Item Name: Baggage Compartment Protector - Floor

DART SERVICE INSTRUCTION

TO AMEND INSTALLATION INSTRUCTIONS IIN-D407-781-2 REV. A OR LATER APPROVED REVISION
AND INSTRUCTIONS FOR CONTINUED AIRWORTHINESS ICA-D407-781 REV. 3 OR LATER REVISION

A	NEW ISSUE		13.04.08
REV.		DESCRIPTION	BY DATE
DESIGN			
DRAWN			
CHECKED			
MFG. APPR.	N/A		
APPROVED			
DE APPR.			
DATE	13.04.08		
		DART AEROSPACE LTD HAWKESBURY, ONTARIO, CANADA	
		DRAWING NO. DSI 9649	REV. A SHEET 1 OF 2
		TITLE ALTERNATE INSTALL	SCALE NTS
		COPYRIGHT © 2013 BY DART AEROSPACE LTD. THIS DOCUMENT IS PRIVATE AND CONFIDENTIAL AND IS SUPPLIED ON THE EXPRESS CONDITION THAT IT IS NOT TO BE USED FOR ANY PURPOSE OR COPIED OR COMMUNICATED TO ANY OTHER PERSON WITHOUT WRITTEN PERMISSION FROM DART AEROSPACE LTD.

**FIGURE 1 - D3879-1 BAGGAGE COMPARTMENT WALL
PROTECTOR - ALTERNATE INSTALLATION**

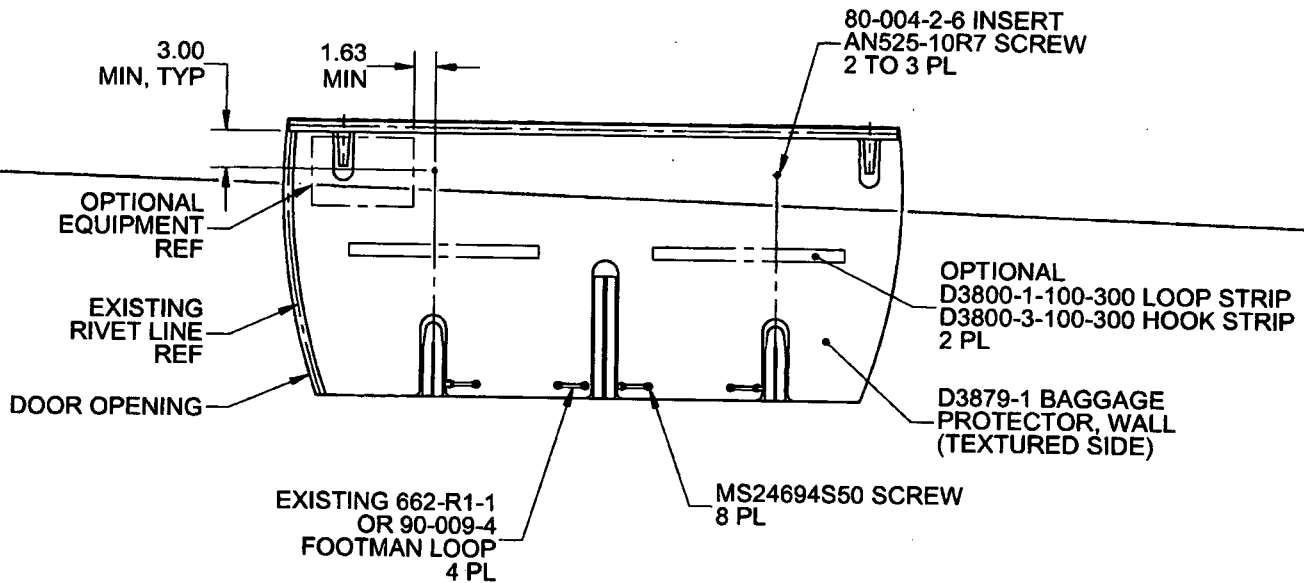
In some aircraft, the top portion of the D206-781-041 Baggage Compartment Wall Protector Kit cannot be installed as indicated in IIN-D407-781-2. The purpose of this DSI is to provide an alternate mounting method to fasten the top portion of the D206-781-041 Baggage Compartment Wall Protector Kit.

It is acceptable to replace qty(2) D3930-1 Clips with qty(2) 80-004-2-6 Inserts. Locate and mark location of the two attachment holes on the baggage compartment wall as shown in Figure 1 of this service instruction. Install 80-004-2-6 Inserts at the marked locations in accordance with Section 3-2-12 of BHT-206-SRM-1. It is acceptable to trim the wall protectors to accommodate optional equipment or transfer attachment holes to the wall protector and install the optional equipment on top of the wall protector with longer fasteners.
